Approval ID : 174591, Dickson 21 /30

Application No: 174591 **Suburb:** Dickson **Block/Section** 21 / 30

Appcn Type: Mixed Use/New Construction with Demolition

Project Title
Dickson Mixed Use
 Block Z1, Section 30, Dickson ACT 2602
Drawing Title
GA Plans
Basement 01

MINIMUM CLEARANCES
INSULATED & BARE
OVERHEAD CONDUCTORS

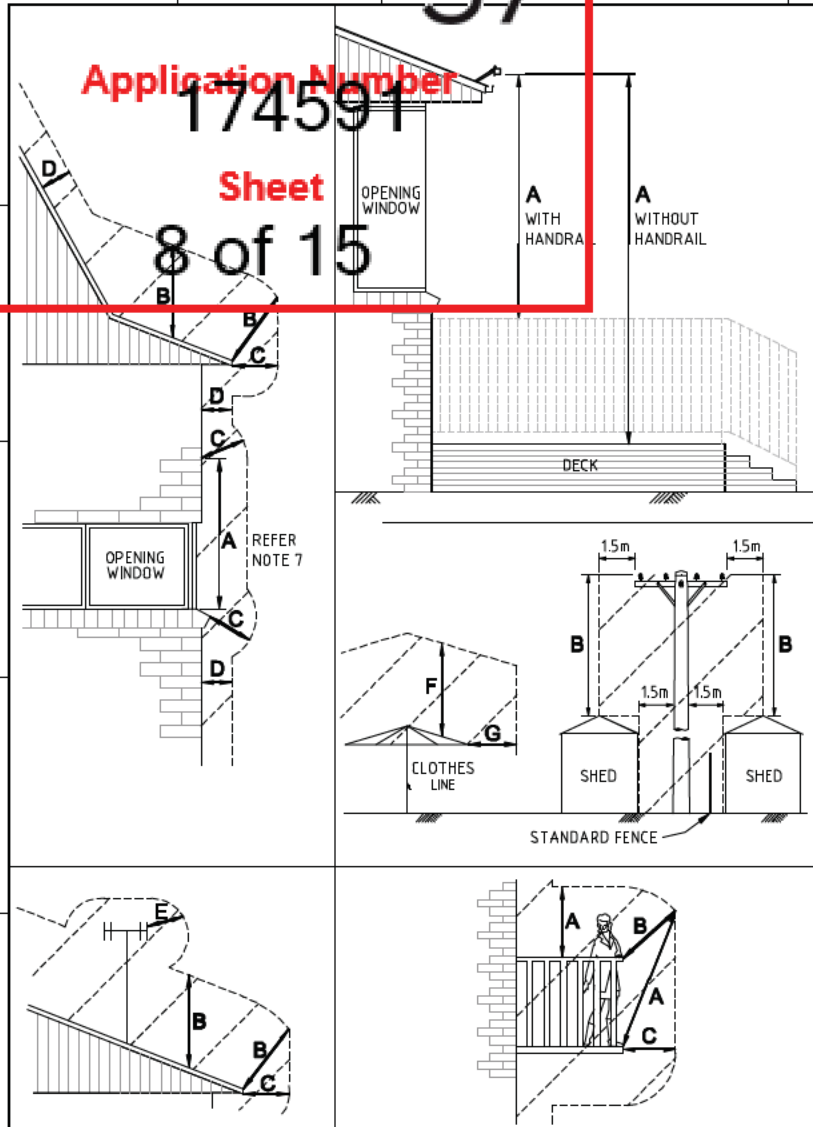
Development is to comply with minimum clearances to overhead conductors and poles. Ref Evoenergy Drawing 3811-004
